## Introduction

The City of Roseville is studying the feasibility of developing a paved multi-use trail within Mahany Park open space which will ultimately connect with existing and proposed paved trails nearby. Part of the Mahany Park open space project area is a public park, but most of the area is considered an open space preserve. Currently, when visitors walk or bike through the area, they create dirt paths that can damage the endangered plants and wildlife within the open space preserve. The study will evaluate factors such as creeks, sensitive habitats and wildlife, topography, safety, aesthetics, and land use impacts. The open space has use limitations and trail suggestions will be considered within those constraints.

### West Option – A: First Preferred Option

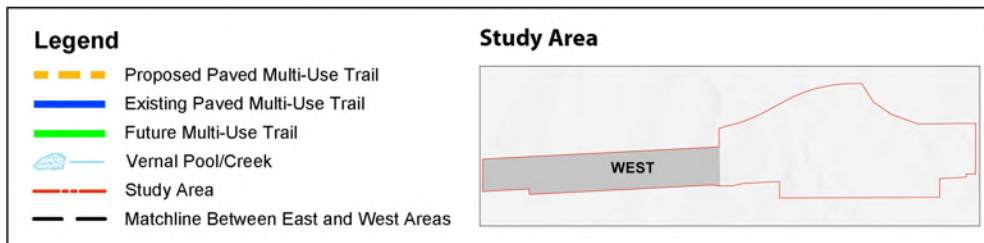
- Participants liked that the trail connects to the sidewalk on Fiddymont Road and is closest to the signalized Pleasant Grove Boulevard Intersection crosswalk
- Some respondents disliked the connection to Fiddymont Road.
- Participants liked the north-south connection between neighborhoods and that construction is expected to be most cost-effective due to straight alignment and avoidance of sensitive habitats.
- Some participants disliked that the trail is on the north side of the study area near adjacent neighborhoods.

West Option – B: Second Preferred Option

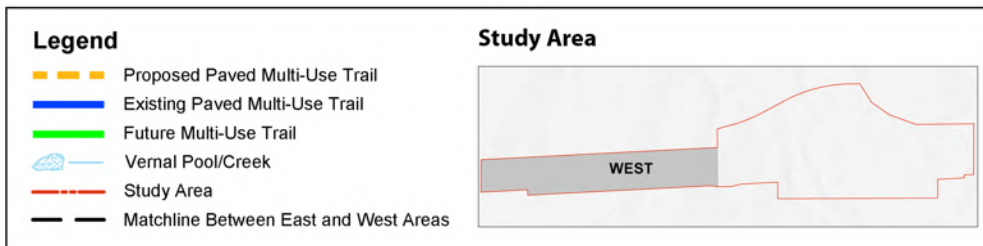
- Participants did not like the trail on the south side of the study area.
- Participants also liked that West Option B has minimal effect on sensitive habitats.

West Option – C: Third Preferred Option

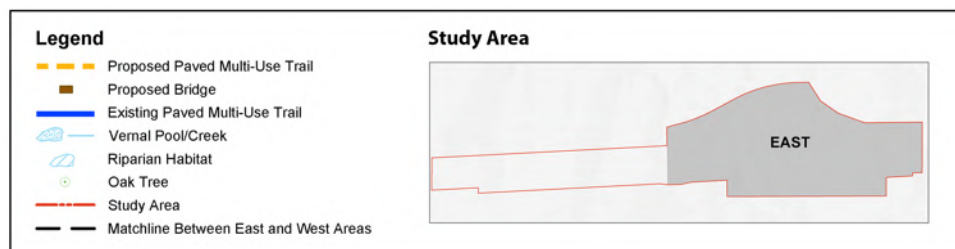
- Some participants liked this option because it would require bike/pedestrian mid-block crossing improvements on Fiddymont Road (e.g., signals, pavement markings, lighting, etc.), allowing for a direct trail connection.
- Participants did not like that this alignment will affect a vernal pool and sensitive habitats and that the alignment is longer
- Participants also disliked that this option would be more costly to construct.

East Option – A: Second Preferred Option

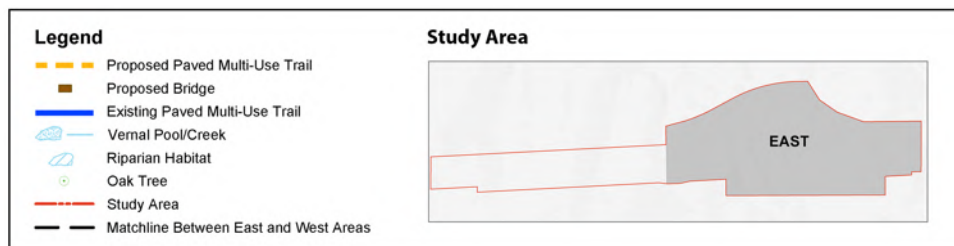
- Participants liked the additional bridge.
- Participants also liked that portions of trail travel through oak woodland, offering shade.
- Some participants liked the north-south connection through the center of the loop.
- Some participants did not like that trail users would need to travel along Pleasant Grove Boulevard to connect to the trail.

East Option – B: First Preferred Option

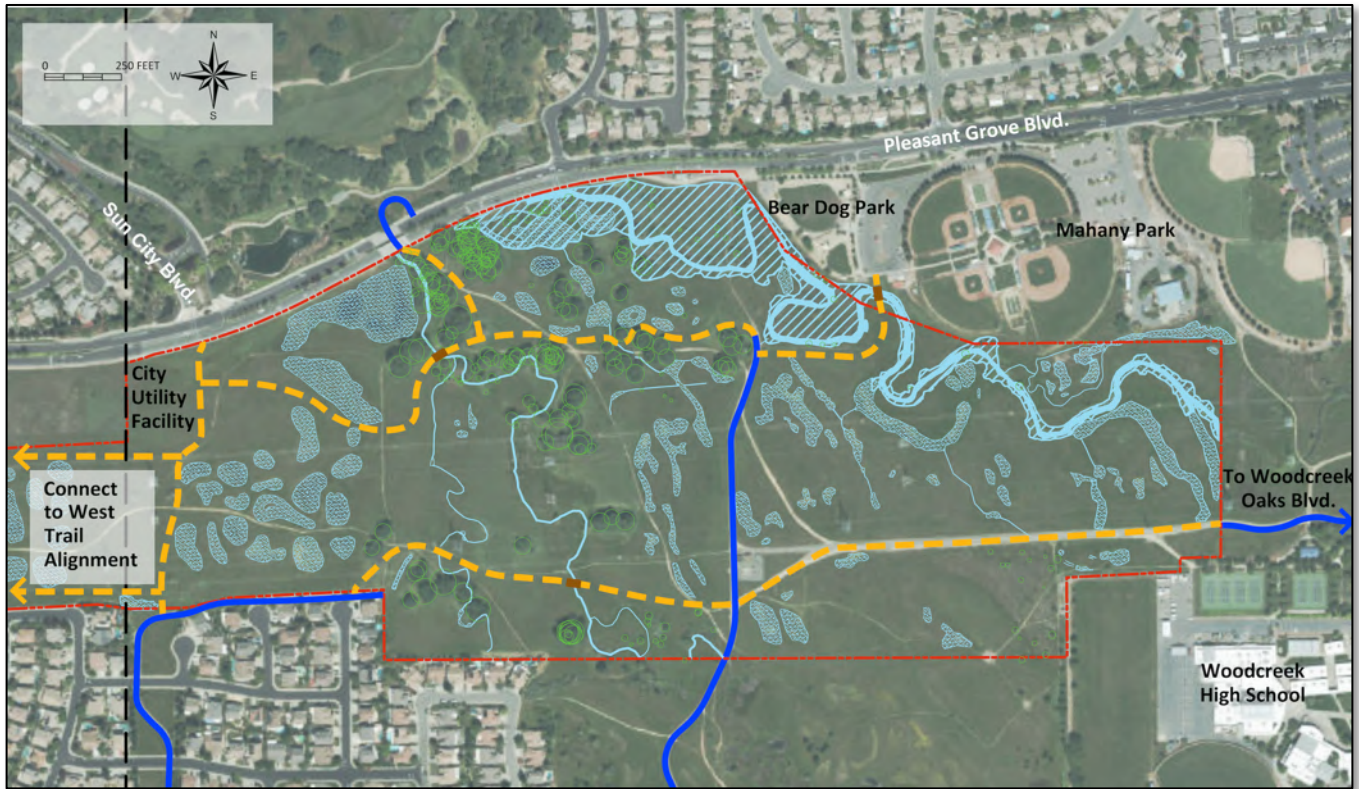
- Participants liked that this option provides a longer recreational “loop” trail.
- Participants also liked the two additional bridges over creeks.
- Participants liked that the trail would allow for trail users to stay off of Pleasant Grove Boulevard and that more portions of trail travel through oak woodland, offering shade.
